VILLAGE OF PERRY

Addendum No. 1

Silver Lake Trail Extension Boardwalk

3/26/2026

Core from location B-7

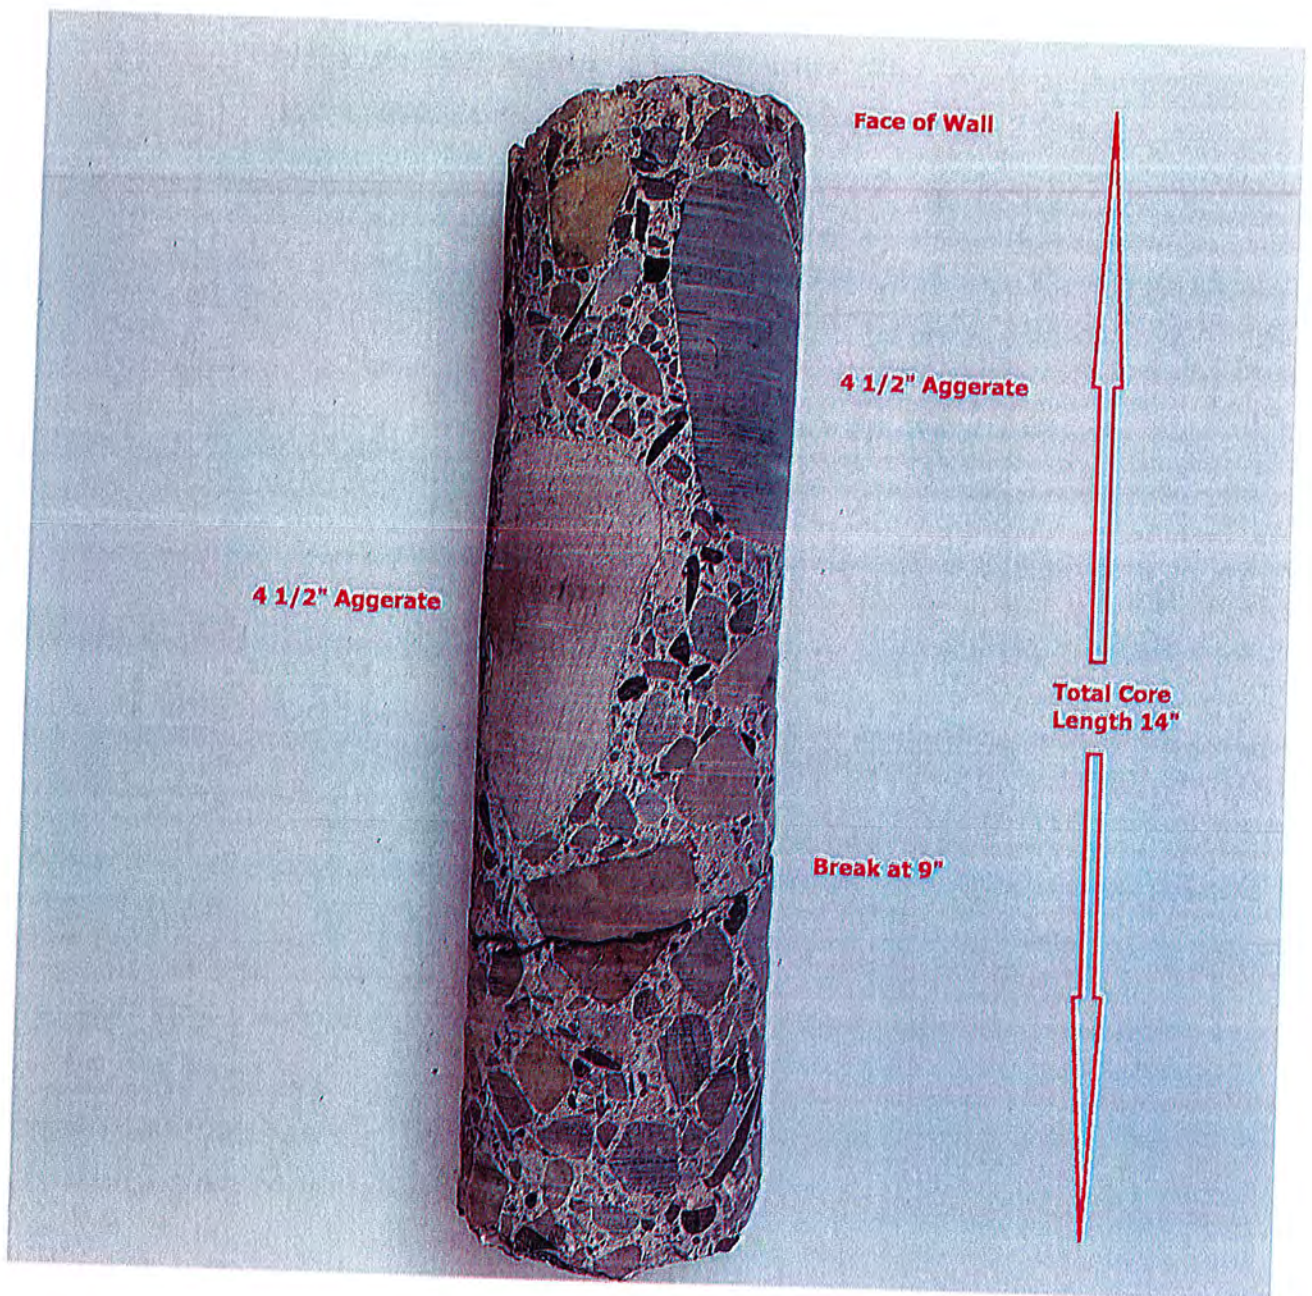
Bridge embankment is thicker than the core length, core did not penetrate through it

Bridge embankment has an overlay layer that is partially weathered away. Surface is fairly intact and the coring showed 'intact' concrete within $\frac{1}{2}$ inch of the surface.

No rebar noted, nor with magnetometer

Swiss Hammer readings indicate an approximate compressive strength of 3,800 psi.
